Rezoning Transportation Analysis

Petition Number: 2026-021

Date	Description
04-23-26	First Review (CM)
05-21-26	Second Review (CM)

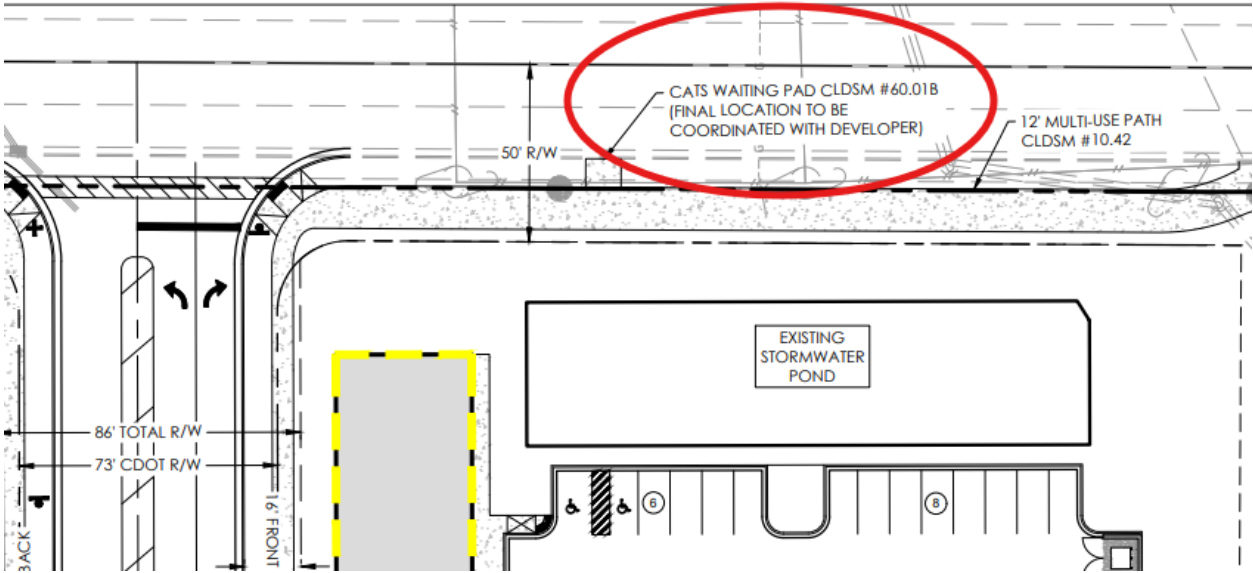
- Revise site plan to show completed streetscape improvements per original rezoning RZP-2021-174. Label and dimension the planting strip width and sidewalk and/or Shared-use-path along Blu Central Road and East Westinghouse Boulevard on page 1 of the rezoning documents as shown on page 3 when referencing RZP-2021-174. Callout as existing on the site plan.

Clarifying Comment 5/21/26: Shared-use path and sidewalk are both existing. Revise shared-use path along Westinghouse to show as existing.
